PRODUCT UPDATE (PU)

BULLETIN : PU-22-01 (REFERENCE: OTI-22-01)

SYSTEM : Frame Mechanical

AFFECTED TANKS : Cat® Articulated Truck-Spray King® manufacturing date prior to 10/26/2022 .

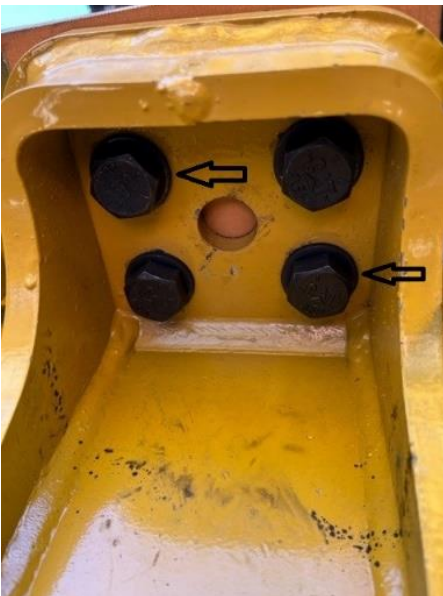
REASON : Under-torqued bolts and potential of missing/incorrect installed hardware on front mounts.

Installation of Cat® Hardware:

- Cap screw (bolt) 1D-4585 QTY required 8
- Nut 4K-0367 QTY required 8
- Washer 5P-8247 QTY required 16
- Torque stripe (thin lacquer)
- Replace rubber pad with ½" Fabri-Flex pad QTY required 2

REVISION CHANGE:

Bill Of Materials (BOM)-Use of Cat hardware and ½" Fabri-Flex
